SUBJECT: AMENDMENT NO. 120 TO FACILITY OPERATING LICENSE NO. DPR-50

THREE MILE ISLAND NUCLEAR STATION, UNIT NO. 1

ATTACHMENT TO LICENSE AMENDMENT NO. 120

SUPPORTING AMENDMENT NO. 120 TO FACILITY OPERATING LICENSE NO. DPR-50

Power Imbalance Envelope for Operation  
After  $250 \pm 10$  EFPD, Cycle 5

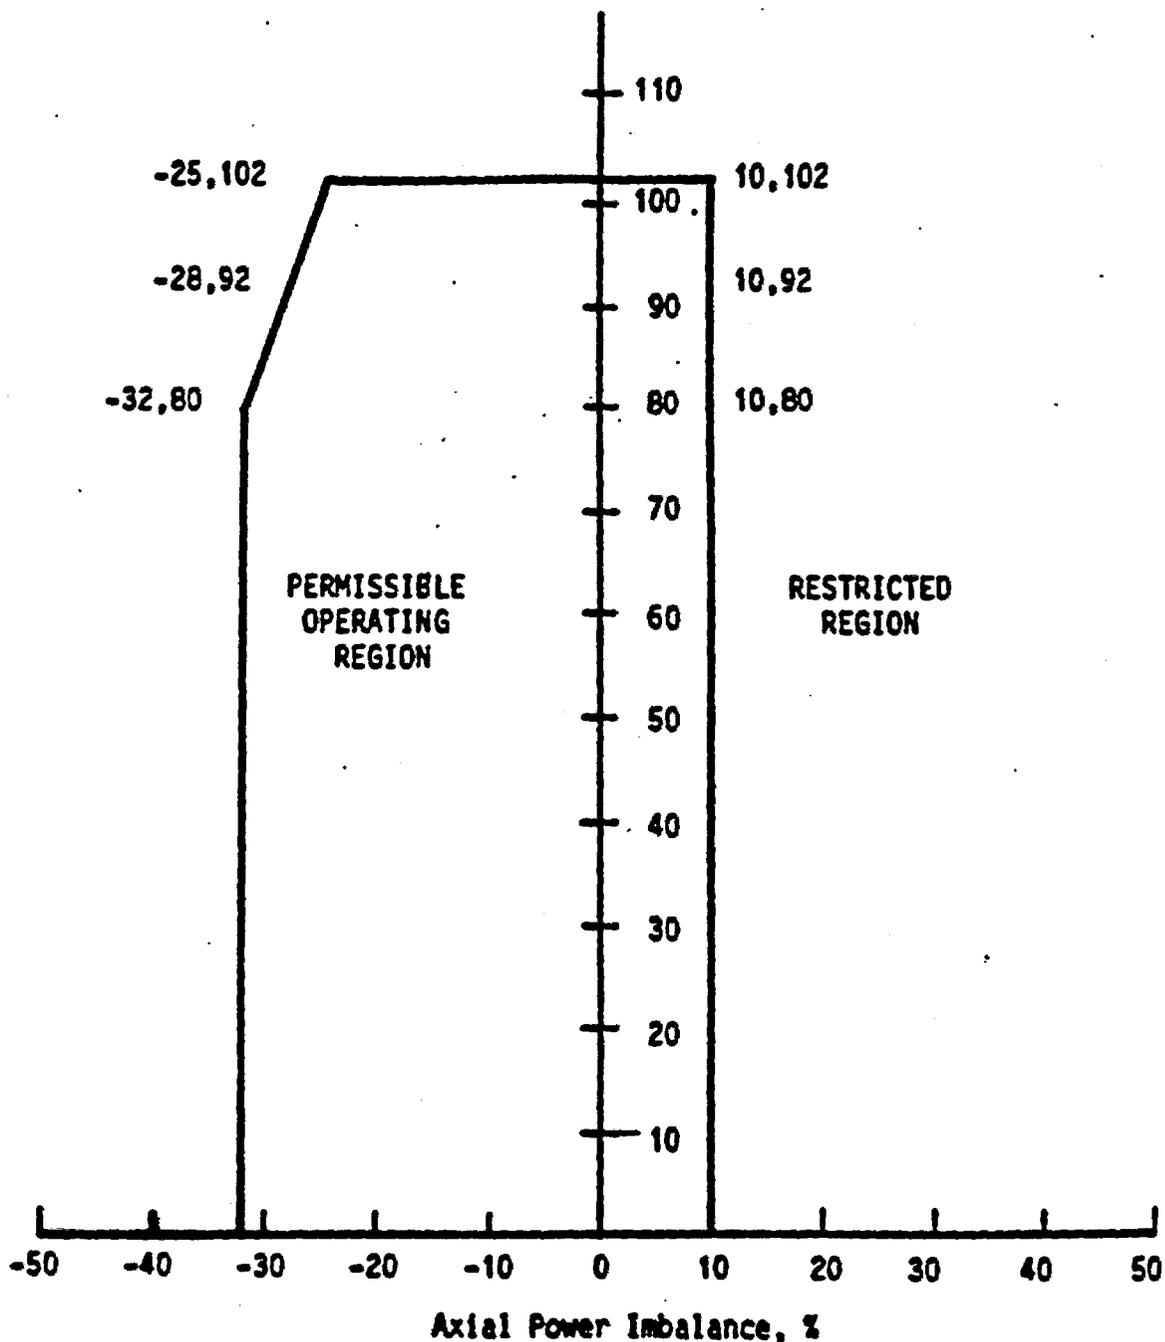
3. The operational imbalance limits (Figures 3.5-2E and 3.5-2F) shall be reduced 2 percent in power for each 1 percent tilt in excess of the tilt limit.

of power distribution control, the licensee determined that the current rod index limits still maintain the shutdown margin and ejected rod worth criteria. The licensee determined new power/imbalance/flow Technical Specification setpoints to meet power peaking factor limits for near EOC 5 operation with the APSRs fully withdrawn. These setpoints are less restrictive than the original Cycle 5 limits which were established with the intention of bounding future cycles. These new setpoints provide the plant with greater operational flexibility. The staff concludes that the licensee's evaluation of the rod index limits and power/imbalance/flow setpoints is acceptable since previously approved methods have been used in the analysis.

APSR Position Limits for Operation  
 From 0 EFPD to 250 ±10 EFPD, Cycle 5

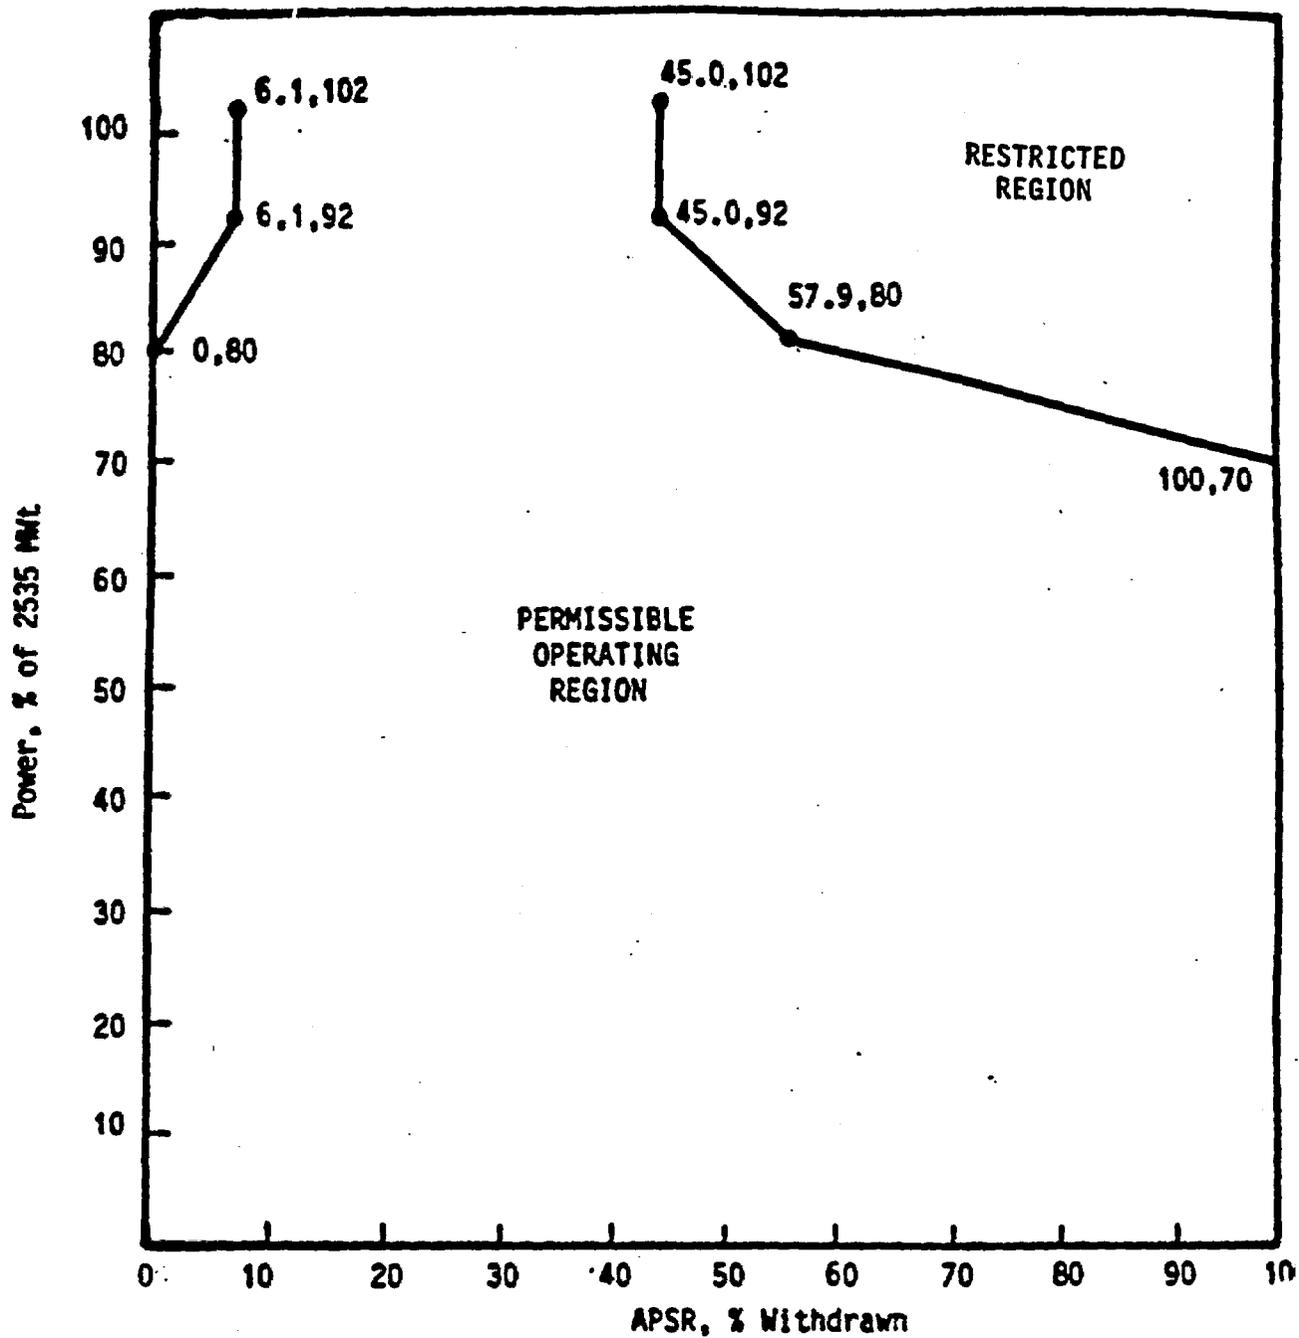
This amendment allows the withdrawal of axial power shaping rods (APSRs) under end-of-cycle (EOC) core conditions. The overall result of this amendment allows continued operation until about November 1, 1986 before beginning the Cycle 6 refueling outage. The portion of your amendment request regarding TS 3.5.2.4 on quadrant tilt is being processed separately.

2. The control rod group withdrawal limits (Figures 3.5-2A, 3.5-2B, 3.5-2C, 3.5-2D, 3.5-2H, and 3.5-2I) shall be reduced 2 percent in power for each 1 percent tilt in excess of the tilt limit.
